# TECHNICAL SERVICE BULLETIN

## 2022-2024 Expedition/Navigator - Random Blind Spot Information System (BLIS) Warning With No Vehicle Or Objects Near Vehicle

**24-2028**

This bulletin supersedes 23-2266. Reason for update: add 2024 vehicles.

Figure 2

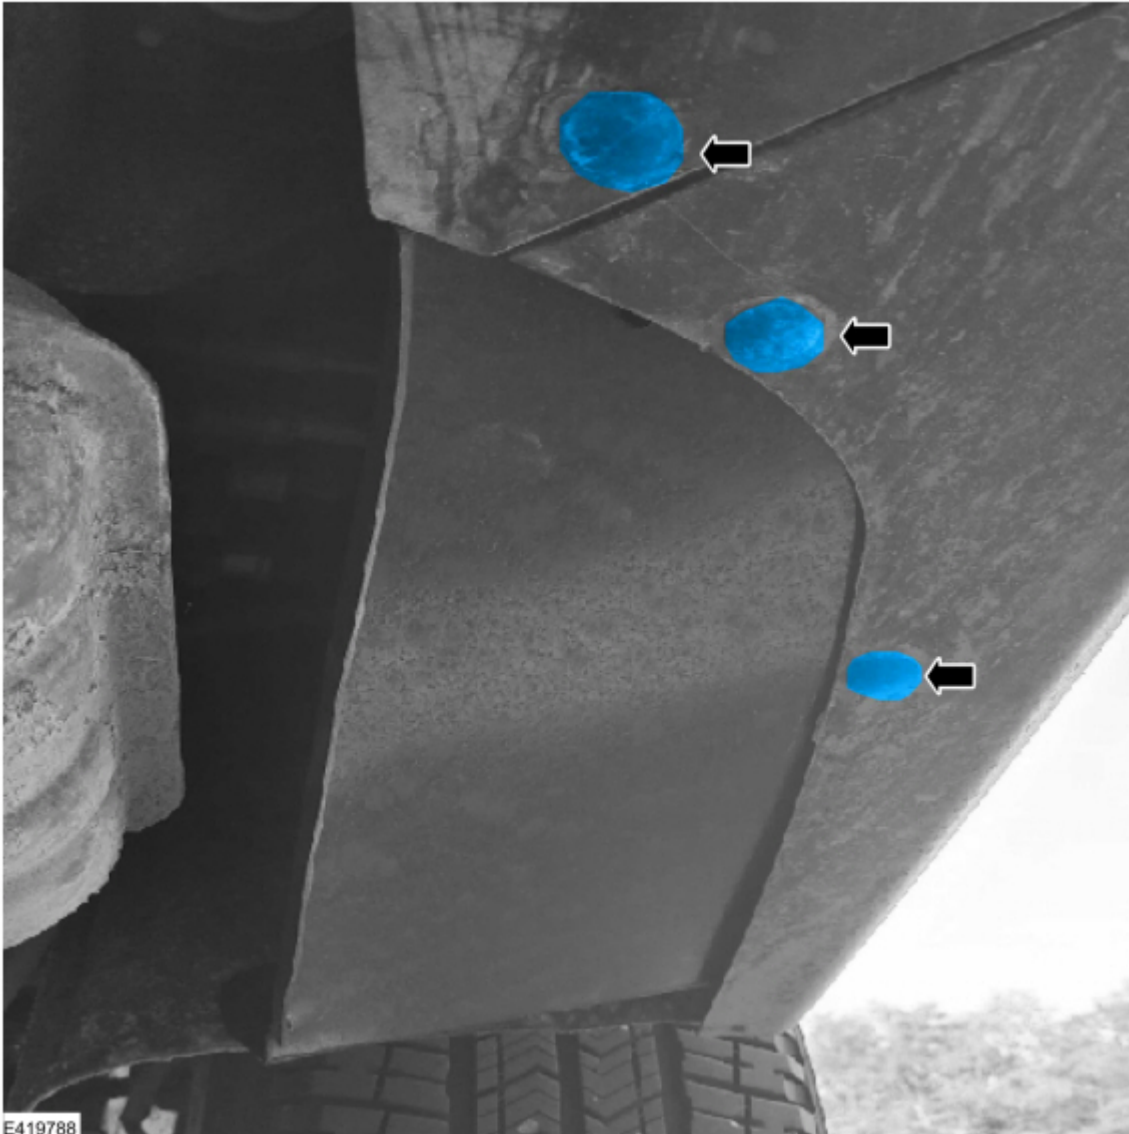
7. Clean the back side of the rear bumper cover opposite the radar sensors. (Figure 2)
